CitiPower/Powercor Technical Standards Update for May 2019

DE and EM Series - New Gas Switch Lead Connections

GB301 & GB711 – 22kV cold applied termination assembly

GC101 & GC401-511- HD Conduit Assembly

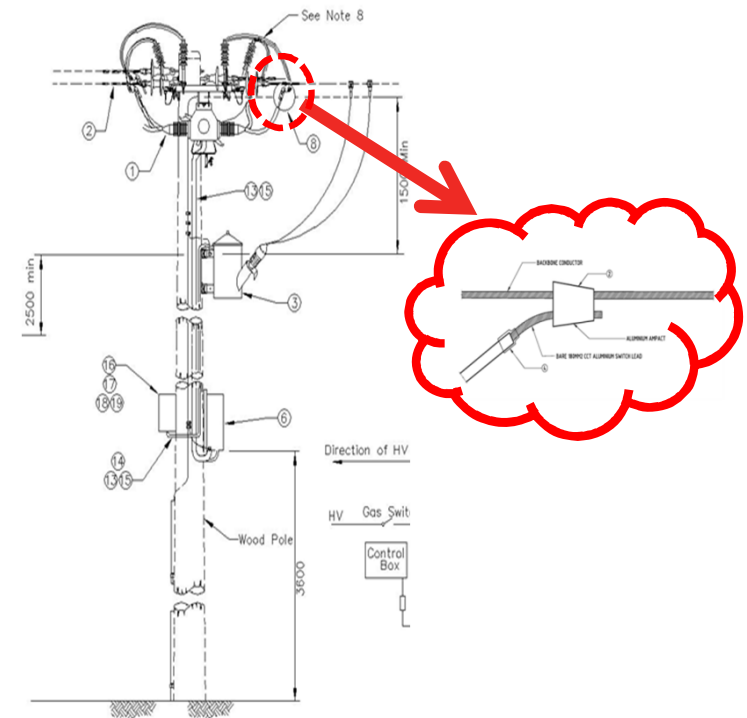
- Technical Standard series DE (connectors) and EM (gas switches) have been updated to include new connection arrangements for gas switch lead connections
- 7 new connection arrangements have been included in the standard to allow connection of the gas switch leads to various overhead conductors
- The connection arrangements have been rationalised to have the minimal amount of connector/fittings as possible
- Some direct connection arrangements to the overhead conductors have now been included
- Heat shrink is to be applied to all connections. While the CCT AI leads are water blocked, the heat shrink provides additional protection from water ingress
- Lead length will be 3.5m (X6) and will be sealed, internal connection to HV bushing of switch.

- The current gas switch lead connection arrangements are out of date and do not represent the various situations encountered in the field. Also a number of connection arrangements have shown over time to result in poor connections that lead to pre-mature failures

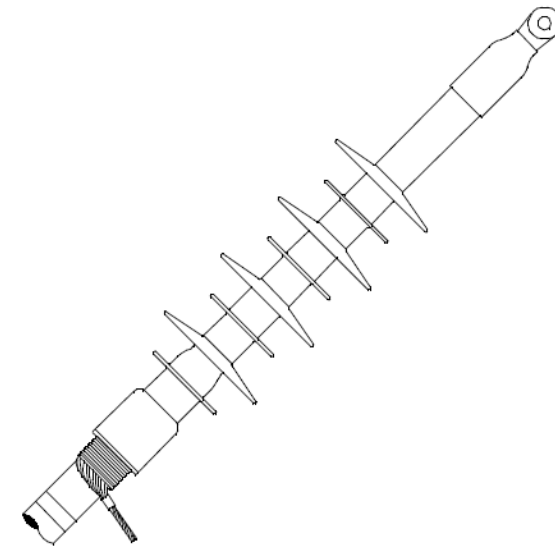
- Technical Standards GB301 and 711 have been updated to include a new 22kV 300mm² cold applied termination kits

- Feedback was obtained from the Geelong U/G team that the existing 22kV 185mm² to 300mm² cold applied termination kit was too tight to fit over a 300mm² cable
- The new termination kit arranges from 300mm² to 500mm² and is a better fit for the cable

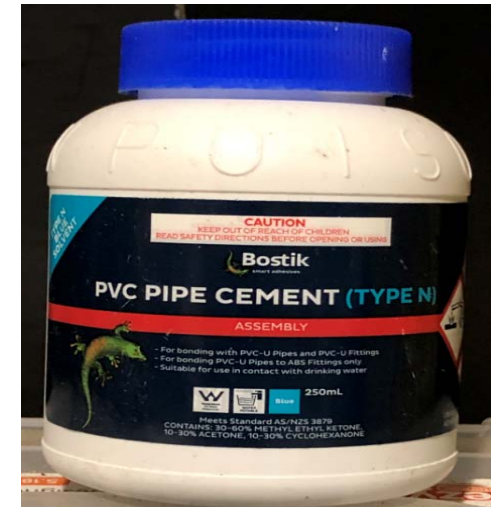
- Technical Standard GC101 has been updated to provide guidance for ordering conduit glue
- Technical Standard GC401-511 has been updated to add conduit glue (SAP ID number 360993).

- The change has occurred due to feedback from material coordinators that conduit glue was not consistently being included in material job lots

GH001 - Hybrid Underground - General Information

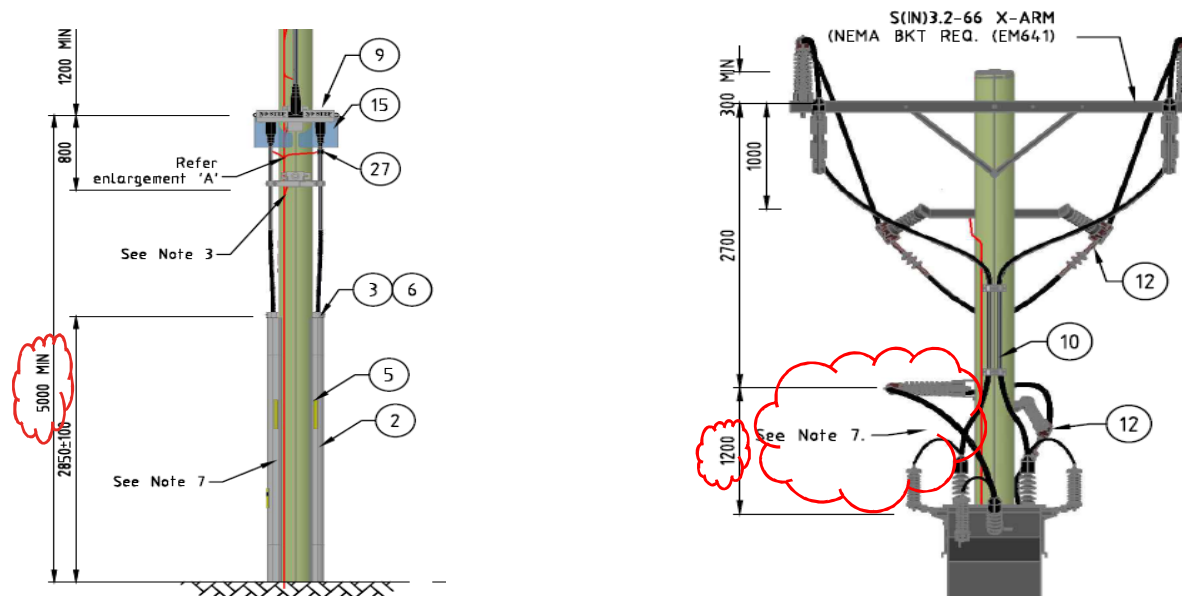
- Technical standards GH101, GH102, GH103 & GH104 have been updated to change the HV support bracket height from a minimum of 4600mm from ground to a minimum of 5000mm
- Technical Standards GH111 has been updated to:
 - increase the spacing between the transformer bracket and bridging post insulator from 1000mm to 1200mm
 - add note 7 which specifies a minimum 330mm clearance between the top of the surge arrester unit or surge arrester connection tail and bridging cable

- The changes are based on post implementation review comments from field construction
